SUBJECT: Waste Management Area-C (WMA-C) 1996 Memorandum of Understanding (Section II., D, and E) briefing provided to the Environmental Protection Agency (EPA) on August 26, 2009

WMAC RFI/CMS Work Plan
Meeting

**EPA TPA Briefing on WMA-C RFI
Work Plan**

Waste Management Area C Work Plan for Corrective Measures

Figure 4-2. Sample Locations for Phase 2 Characterization

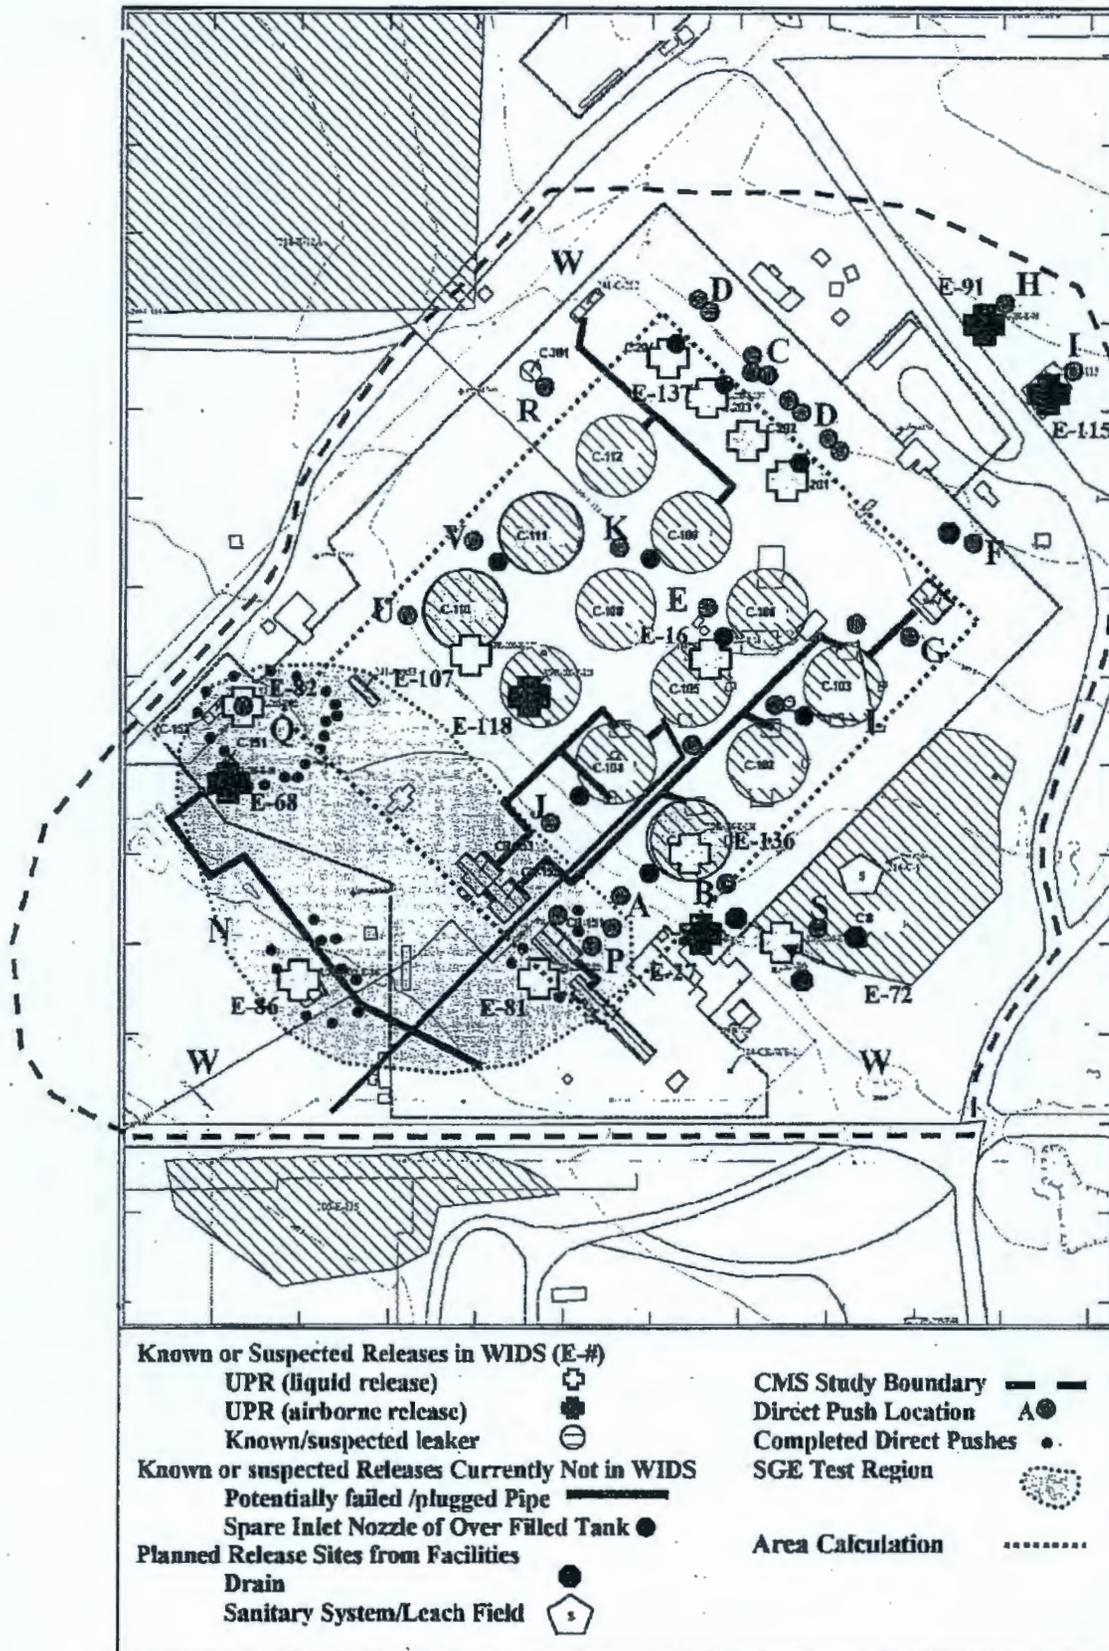
Can they push to 200'? Basic assumption in their plan.
1st + then 2nd push idea is good (log, then collect soil samples)

Why ~~is~~ is the max depth for C-100 Series tanks 200 ft,
and for 200 series it is 160 ft max? Why don't we
want to know what is below that depth?

Figure 3-2 All the data collection is within the
red dotted perimeter, but the study boundary
is shown larger (yellow dotted line).
There is no study planned between the
red dots & yellow dotted line.
